R-15 OSC Plan

Knight Road Community

PETITION NO: Z-36

ZONING COMMENTS:

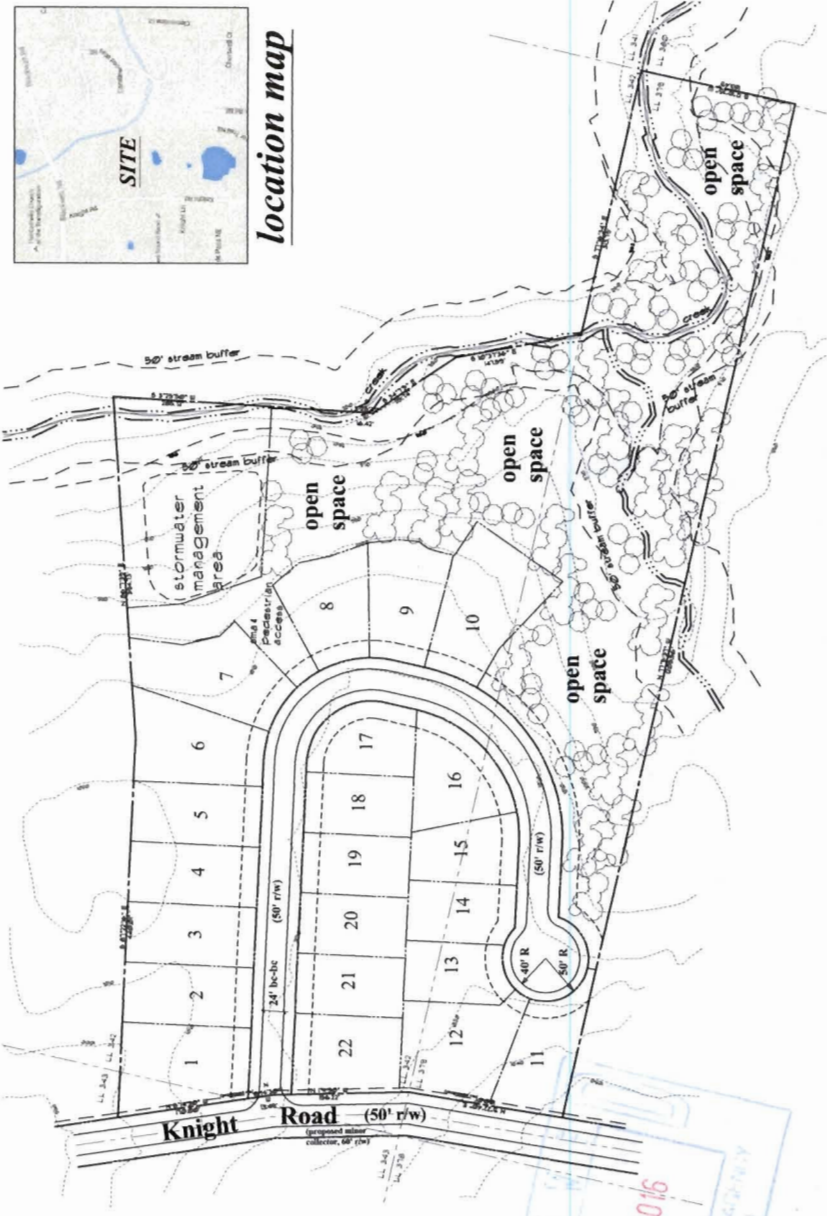
Development as proposed on site plan received on 03/03/16 does meet the technical requirements of the OSC ordinance and the required percentage of open space that allows a density bonus up to 2.25 units per acre for an R-15 OSC. To further enhance this proposal the following comments and recommendations should be met.

1. Overall residential development shall be compatible with neighboring residential uses. Consider modifying exterior lots 1 – 7 to incorporate larger lot sizes adjacent to existing residential lots.
2. Must have Cobb Department of Transportation approved lighting plan in if outdoor lighting (except individual residential lots) is proposed
3. A Conservation Easement must be recorded in the mandatory subdivision covenants and with Cobb Superior Court, thereby protecting the “Open Space” from development in perpetuity as owned by the mandatory Home Owners Association. Conservation Easement application must be submitted to the Planning Division before final plat approval.

Recommend providing site plan that list lot sizes for each lot for compatibility purposes

1. This 13.0 site is located to the east of Knight Road between its intersection with Blackwell Road and Knight Lane. The majority of the site drains to the west directly into the Rubes Creek floodplain. Approximately 3.2 acres of the northwest corner drains to the northwest to the Knight Road right-of-way. The parcel is mostly wooded with slopes ranging from 4% near the road to 35% or greater at the rear adjacent to the creek.
2. The proposed Open Space plan appears to keep all of the lot footprints outside the slope areas that exceed 25%.
3. A drainage easement may be required at the rear of lots 1 – 4 to direct runoff directly to the Knight Road right-of-way.
